State of New Mexico  
 Energy, Minerals and Natural Resources

WELL API NO.	30-045-34193
5. Indicate Type of Lease	STATE <input checked="" type="checkbox"/> FEE <input type="checkbox"/>
6. State Oil & Gas Lease No.	314636
7. Lease Name or Unit Agreement Name	NAVAJO LAKE 14
8. Well Number	1
9. OGRID Number	370292
10. Pool name or Wildcat	BASIN FRUITLAND COAL (GAS)
11. Elevation (Show whether DR, RKB, RT, GR, etc.)	6182' GL

**SUNDRY NOTICES AND REPORTS ON WELLS**  
 (DO NOT USE THIS FORM FOR PROPOSALS TO DRILL OR TO DEEPEN OR PLUG BACK TO A DIFFERENT RESERVOIR. USE "APPLICATION FOR PERMIT" (FORM C-101) FOR SUCH PROPOSALS.)

# Navajo Lake 14-1

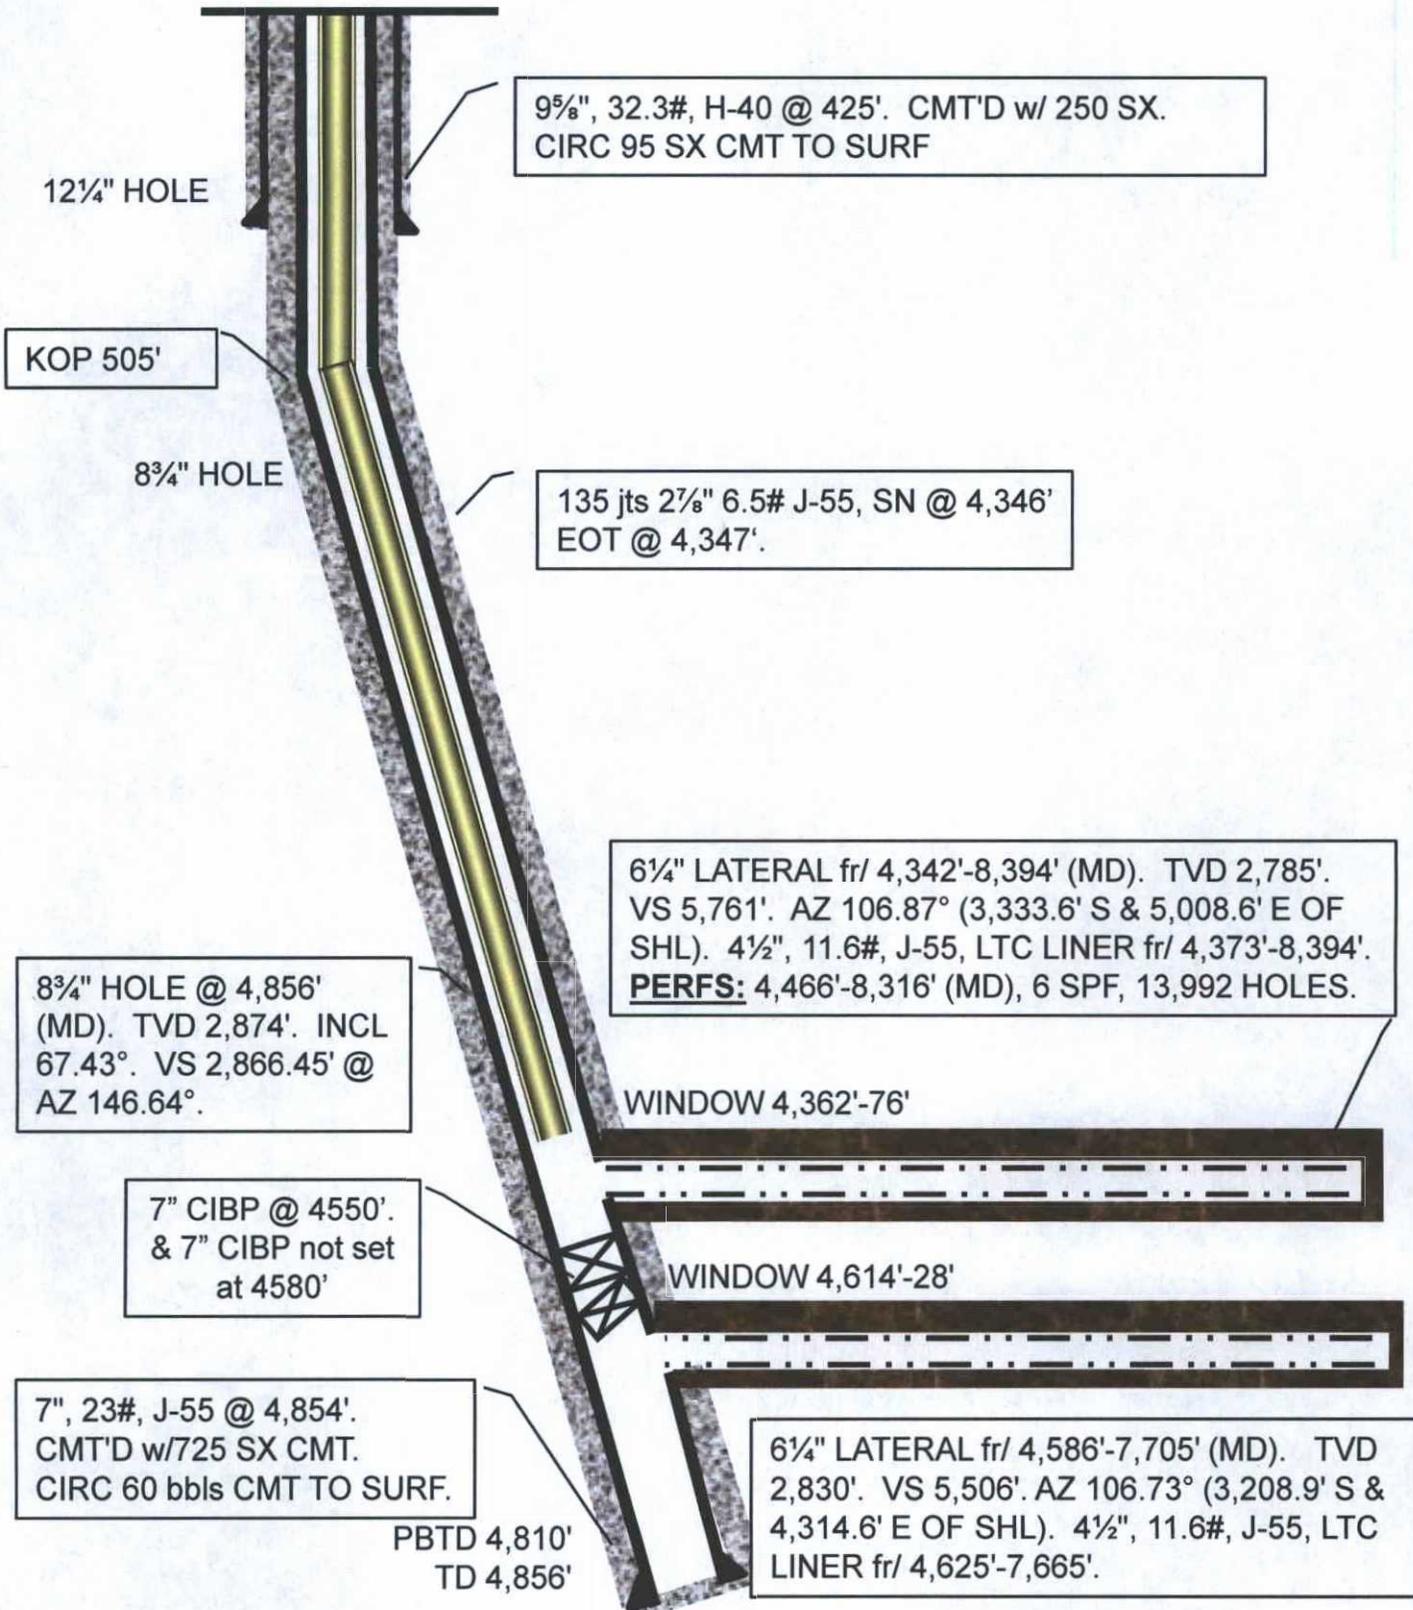
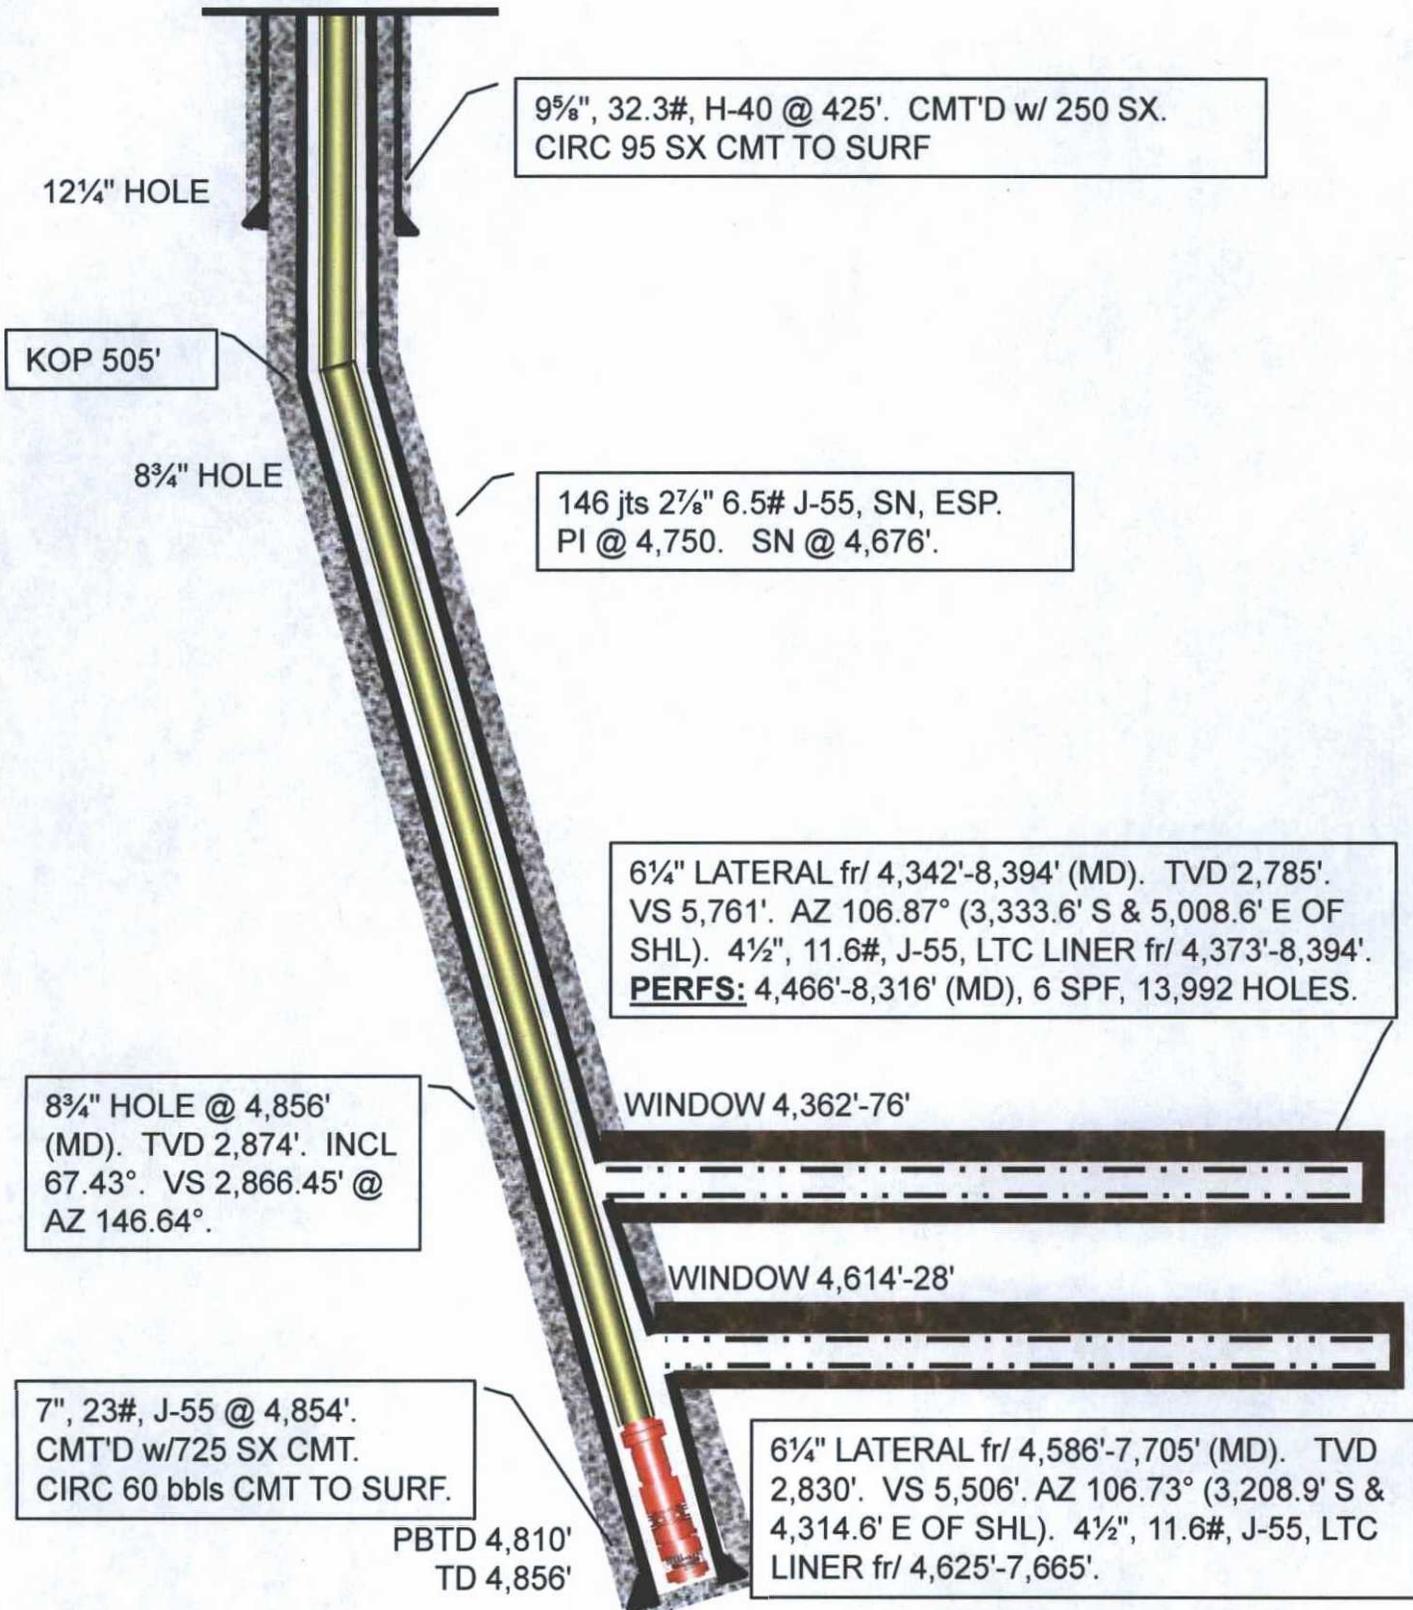
On June 3, 2015 a 7" CIBP was set to test the upper lateral formation (Fruitland Coal) production. SRC's Field personnel believed the sundry had been filed by Energen at the time the plug was set. No notice was filed at that time and this well may be out of compliance.

Southland Royalty is proposing to remove the plug and return the well to the same set up as before. Please see attached current wellbore and proposed schematics. With NMOCD's approval, SRC's proposed date to remove the plug is November 30, 2015.

7" CIBP @ 4550'.  
 & 7" CIBP not set  
 at 4580'

*# in the future ensure compliance with 19.15.7.14*
